BELMONT OAKS SUBDIVISION

APPLICATION NUMBER 7 DATE May 3, 2018

DETAIL SITE PLAN

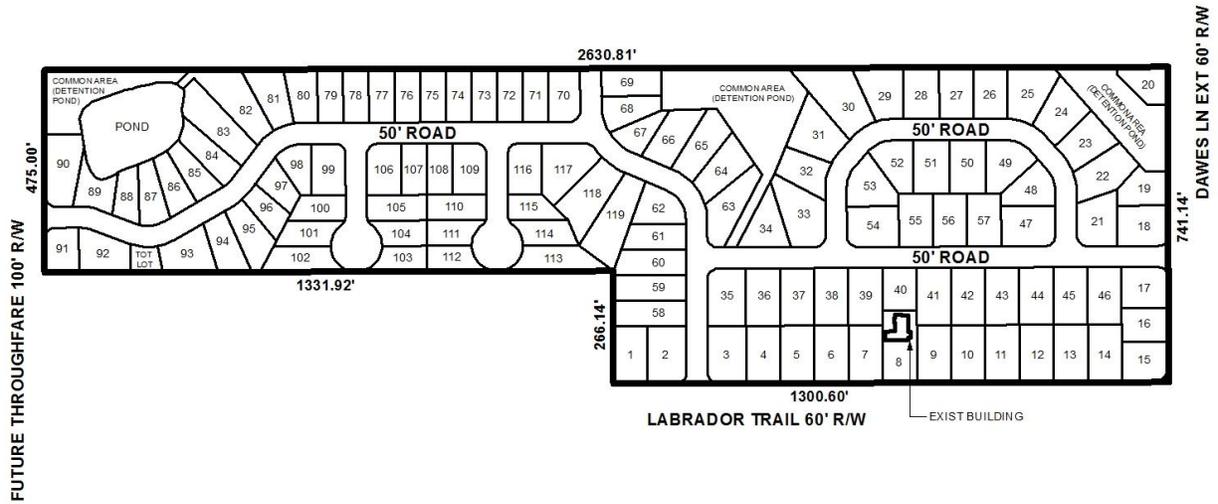
While street access by a majority of the proposed lots will be limited to the proposed connector streets and closed-end streets within the subdivision, or to Labrador Trail, access along Lots 16, 19, and 20, as well as along one (1) of the Common Areas, is exclusively limited to Dawes Lane Extension. Additionally, Lots 15, 17, and 18 will have double frontage to Dawes Lane Road and to one (1) of the proposed connector streets; Lots 90 and 91 will have double frontage to another of the proposed connector streets, as well as to the proposed Airport Road extension, if constructed; and one (1) additional Common Area is inaccessible *until* construction of the proposed Airport Road extension.

Because large subdivisions inherently generate additional traffic as a result of additional vehicles having access to existing streets, it may be appropriate to limit access to Dawes Lane Extension. Revision of the plat to reconfigure or remove Lots 16, 19, and 20, as well as the Common Areas along Dawes Lane Extension and the proposed Airport Road extension will be necessary to do so. Additionally, access to all of the proposed lots should be limited to one (1) curb cut each. A note should, therefore, be placed on the Final Plat, if approved, stating each lot and Common Area is denied access to Dawes Lane Extension and the proposed Airport Road extension, and is limited to one (1) curb cut each to their respective unnamed roads along which they have frontage, with any changes in their sizes, locations, or designs to be approved by Mobile County Engineering and conform to AASHTO standards.

The 25' minimum building setback line is not illustrated along the frontage of any proposed lot or Common Area, as required by Section V.D.9. of the Subdivision Regulations. If approved, the plat should be revised to illustrate the 25' minimum building setback line along all street frontages, adjusted for any required dedication.

Many of the proposed lots are slightly irregularly shaped, which is seemingly the result of the design of the proposed connector streets, but none of the lot sizes are provided; therefore, it is difficult for Staff to determine if they will meet the minimum size requirements for lots served by public water and sanitary sewer systems. The sizes of the proposed Common Areas are also not provided. Additionally, many of the proposed lots do not appear to meet the minimum width requirements of the Subdivision Regulations, and not all lot widths are illustrated. A note on the plat states there is a 60' minimum lot width at the setback line, but without illustration of the setback line, staff cannot verify the remark. If approved, revision of the plat to provide the sizes of each lot and Common Area, as well to provide the widths of each lot and Common Area along each street on which they have frontage should be required, adjusted for any required dedication; or, provision of a table on the Final Plat providing the same information may suffice.

Regarding what is labeled as the “Tot Lot,” its purpose to the subdivision has not been identified by the applicant, and it does not meet the minimum size requirements for lots served by public water and sanitary sewer systems. As such, revision of the plat to label the “Tot Lot” as Common Area may be appropriate.

- 1) revision of the plat to provide or illustrate a definite plan/layout for each subdivision phase;
- 2) revision of the plat to accommodate the proposed 120’-wide right-of-way of the Airport Road extension per the Major Street Plan, including the necessary dedication of land to Mobile County;
- 3) revision of the plat to illustrate right-of-way widths in compliance with Section V.B.14. of the Subdivision Regulation along all proposed streets within the subdivision;
- 4) revision of the plat to ensure no proposed lots or Common Areas have access to Dawes Road Extension;
- 5) revision of the plat to ensure no proposed lots or Common Areas have access to the proposed extension of Airport Road;
- 6) revision of the plat to provide the sizes of each lot and Common Area in both square feet and acres, or the provision of a table providing the same information;

- 7) revision of the plat to clearly identify the widths of each lot, and the widths of the access to each Common Area, as reconfigured on the revised plat;
- 8) provision of the 25' minimum building setback line along all street frontages where lots and Common Areas are at least 60' wide; and,
- 9) revision of the plat to label the "Tot Lot" as a Common Area;
